PCN/21/015/C+N-US

Product range: Interface connectors / InduCom

Title: Change of head shape of M3 hexagonal locking screws

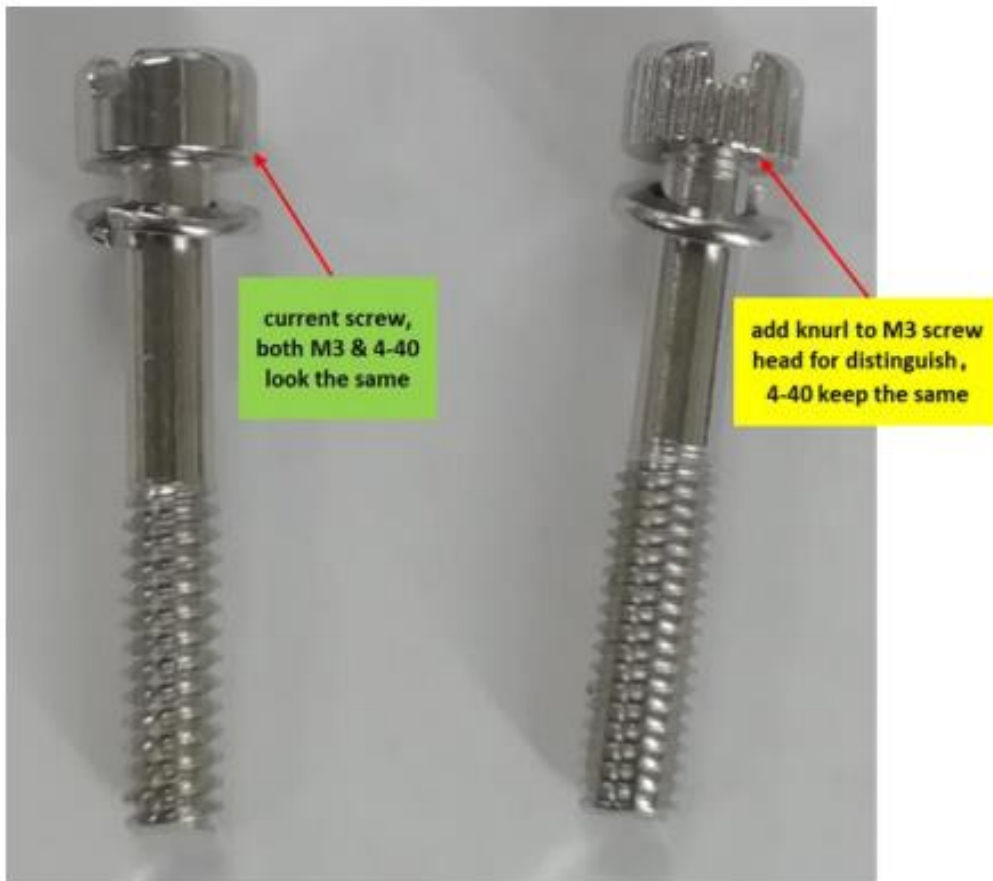
For a better identification of InduCom-partnumbers with M3 hexagonal locking screws, we add a knurl to the screw head. The hexagonal locking screws with UNC4-40 thread will keep the flat surface.

The change is visible from the outside, see picture above. The part numbers will be kept unchanged, the revision level will be increased (details see list of concerned part numbers).
